Clarification Questions and Responses

Project Title: Supply, Delivery and Installation of one (1) Oxygen Generator

Date: 10th February 2023

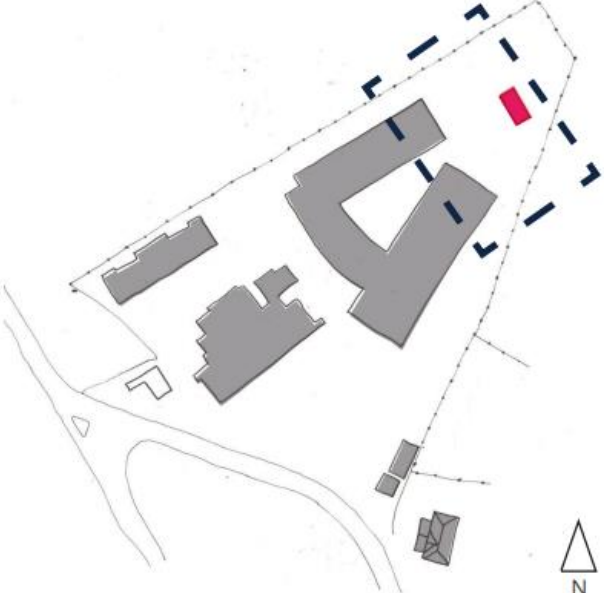
Clarification Question	Government of Montserrat (GoM) Response
<p>1. The tender document shows Montserrat Dollars. Is this project for local contractors only?</p> <p>Will you consider international manufacturing firms quoting in USD\$?</p>	<p>Quotes in USD are to be converted to EC\$ using the rate of 2.7169. Form of Tender is to be completed in EC\$.</p> <p>The project is for local, regional and international contractors.</p>
<p>2. What is the project budget estimate please?</p> <p>Does the budget estimate allow sending international experts for installation, training and commissioning of the Oxygen Generator plant?</p>	<p>Any expense associated with experts for installation, training and commissioning of the Oxygen Generator plant should be included in the proposal.</p>
<p>3. Do you have any drawings/photos of the intended installation site?</p>	<p>Very rough plan inserted. Awaiting more detailed plan from the architect.</p>
